VIRGINIA ELECTRIC AND POWER COMPANY
RICHMOND, VIRGINIA 23261

VIRGINIA ELECTRIC AND POWER COMPANY
SURRY POWER STATION UNITS 1 AND 2
REQUEST FOR ADDITIONAL INFORMATION
ASME SECTION XI RELIEF REQUESTS SR-27, 28, 32 and 33
ALTERNATIVE REPAIR TECHNIQUE - REACTOR VESSEL HEAD

Request for Additional Information

Figure 1

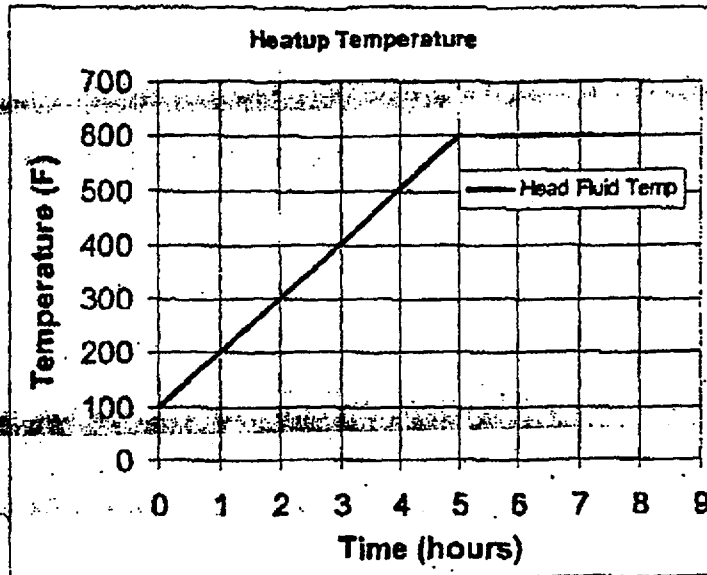
- For heatup, Framatome's heatup curve (Figure 1) shows a rate of 100°F/hr and a range of 100°F to 600°F. This heatup rate matches the design rate for Surry. The range bounds Surry's design range. For design purposes, an ambient temperature of 70°F was assumed, and the no-load RCS temperature is 547°F. Per Reference 4, the full power upper head mean fluid temperature for Surry is 597.8°F. Therefore, the heatup rate and range proposed by Framatome are judged to be bounding. Framatome's heatup pressurization curve (Figure 2) shows an approximate rate of 645 psig/hr. This number does not bound the design value of 740 psig/hr; however, it bounds the actual pressurization rates used during plant heatup.

Figure 3

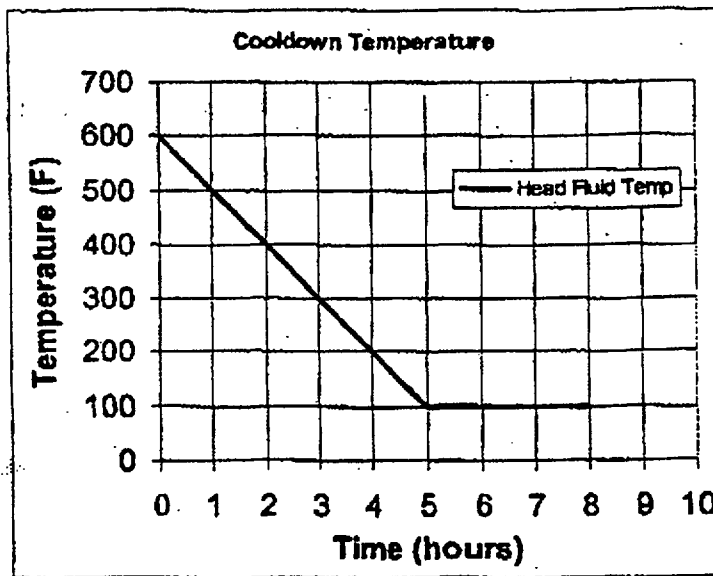
- For cooldown, Framatome's cooldown curve (Figure 3) shows a rate of -100°F/hr and a range of 600°F to 100°F. This cooldown rate matches the design rate for Surry. The range bounds Surry's design range as discussed above. Framatome's cooldown pressurization curve (Figure 4) shows an approximate rate of -645 psig/hr. This number does not bound the design value of 740 psig/hr; however, it bounds the actual rates used during plant cooldown.

Figure 9

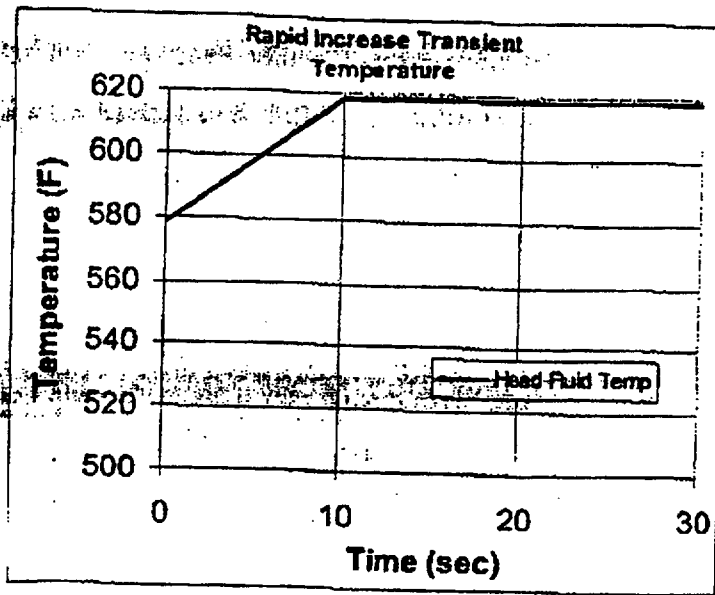
- For the remaining transients of increasing temperatures, Framatome proposes 2800 occurrences of a transient from 577°F to 617°F (+40°F) in 10 seconds (Figure 9), accompanied by a rise in pressure from 2235 to 2585 psig (+350 psi) (Figure 10). For the remaining transients of decreasing temperatures, Framatome proposes 2800 occurrences of a transient from 617°F to 517°F (-100°F) in 10 seconds (Figure 11), accompanied by a drop in pressure from 2235 to 1735 psig (-500 psi) (Figure 12). Review of the 10% step increase, 10% step decrease, large step decrease in load (with steam dumps), loss of load, loss of flow, reactor trip, turbine roll, and loss of power design basis transients show that they are collectively bounded by the transients assumed by Framatome, both in magnitude and number of occurrences.
